WORK DESCRIPTION FOR FIELD MEASURE

Code: 21P1591015

Replace bolts for centering flange on integrated starter-alternator

Model 167 with M177

Figure 1

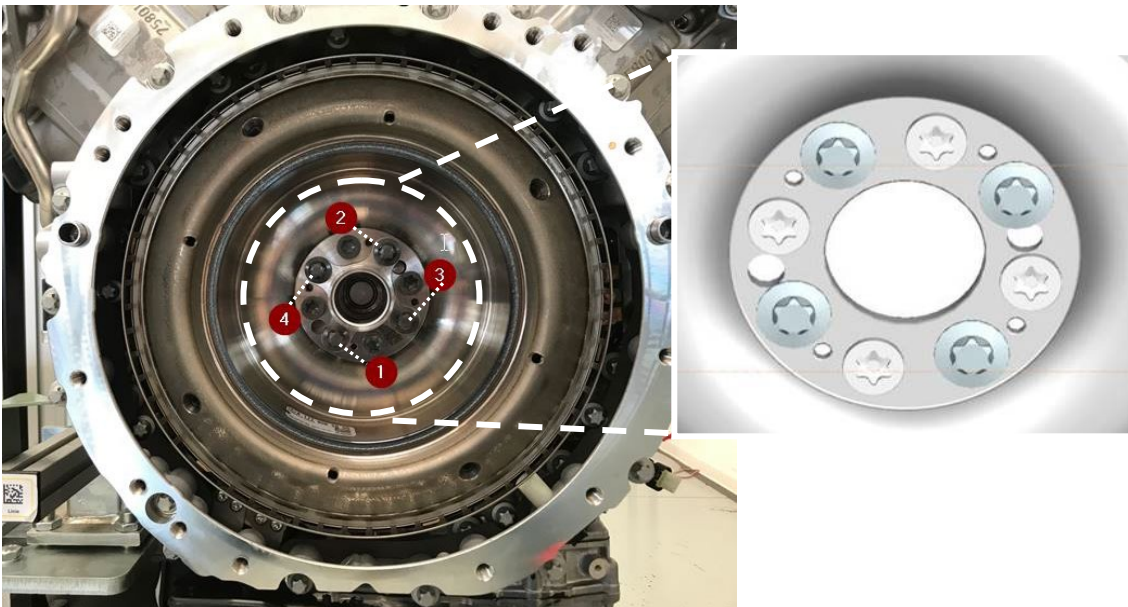
1. Remove transmission with torque converter
 - i** For basic data, see **AR27.10-P-0500MNO**
2. Replace **external** Torx bolts (1 to 4, figure 1) for centering flange on integrated starter-alternator.
 - i** Replace bolts individually in succession.
 - Nm** Bolt, centering flange to starter-alternator 1st phase **45 Nm** – 2nd phase **90°**
 - i** Secure engine against turning.
